## ADDENDUM NO. 3

<b>Issue Date:</b>	March 8, 2024
<b>School / Facility Name:</b>	DeLand High
<b>Project Name:</b>	Softball Field Lighting
<b>Owner's Project No.:</b>	2448067

<b>Engineer's Representative:</b>	Adrian W. Baus, PE, RCDD
<b>Engineer's Project No.:</b>	2023-130

**SITE PLAN-ELECTRICAL**

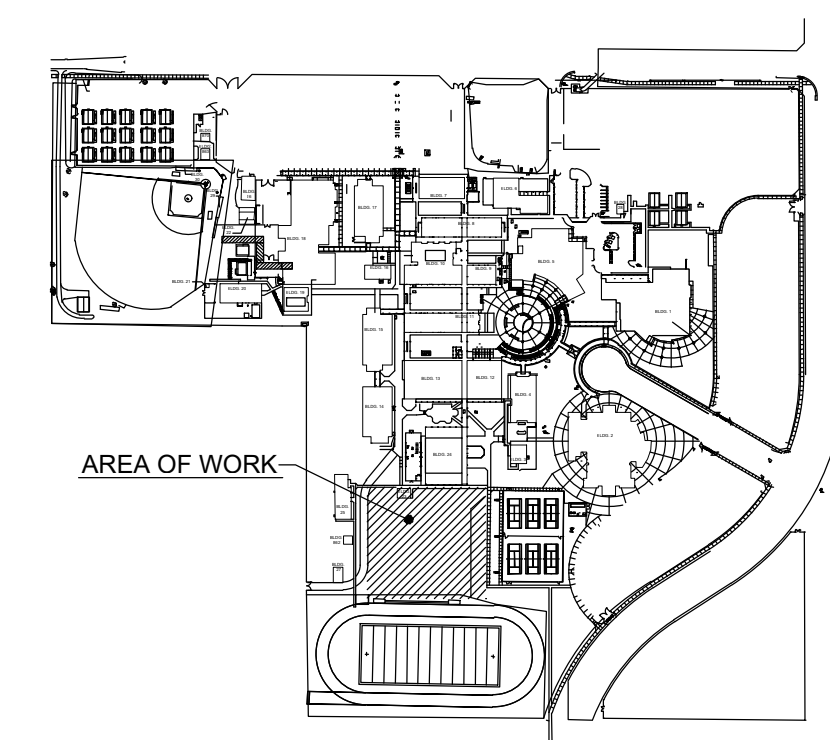
### **1. SHEET E100 SITE PLAN – ELECTRICAL**

- a. REVISE: location that HSBF-6,8 homerun is connected to.
- b. ADD: Note clarifying that conduit and controls for area lighting shown on sheet shall be bid as part of Additive Alternate No. 1.

△ AREA LIGHTING INCLUDING CONDUIT, AND LIGHTING CONTROLS SHOWN ON THIS SHEET SHALL BE BID AS PART OF ADDITIVE ALTERNATE NO. 1.
